# Rezoning Transportation Analysis

Petition Number: 2023-033

Date	Description
7-26-23	First Review (IW)
08-24-23	Second Review (NK)
9-20-23	Third Review (NK)
10-25-23	Fourth Review (NK)
11-27-23	Fifth Review (NK)
4-23-24	Sixth Review (NK)

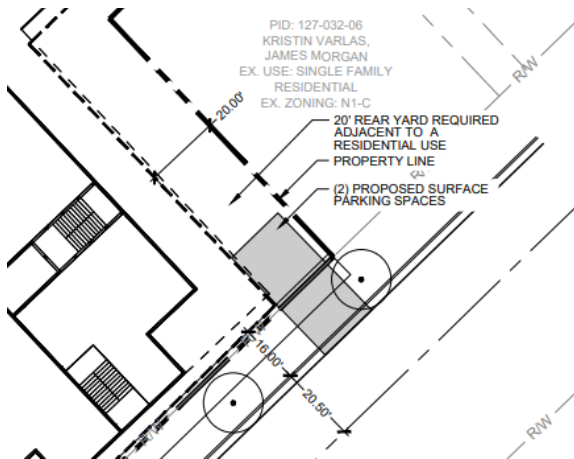
- ~~8. CDOT requests that the petitioner revise site plan and conditional note(s) to commit to upgrading the rapid flashing beacon pedestrian crossing at Clement Ave and E. 7<sup>th</sup> Street.~~

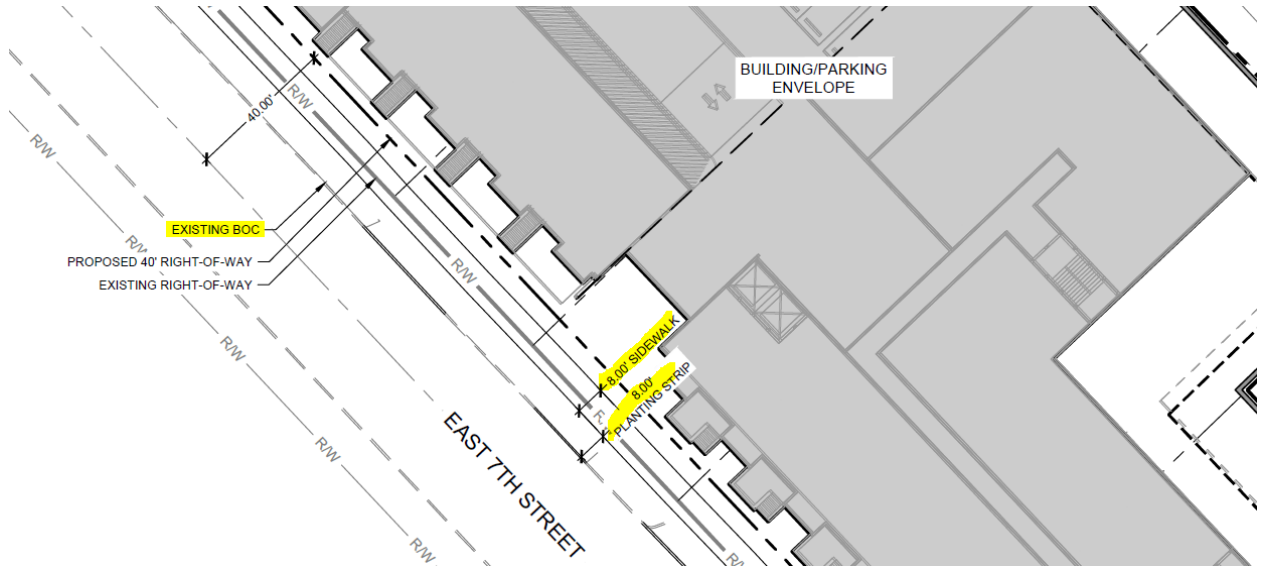
13. **New Comment 10-26-23:** Revise site plan to show future curb line located 27’ from centerline of E. 7<sup>th</sup> Street. Preservation of future curb line allows installation of bicycle facilities in the future to include buffered bicycle lanes. Preservation of space for future buffered bicycle lanes meets Council-adopted Charlotte BIKES policy. Current plan revision removed preservation of space for bicycle facilities and does not accommodate any form of future bicycle facilities.
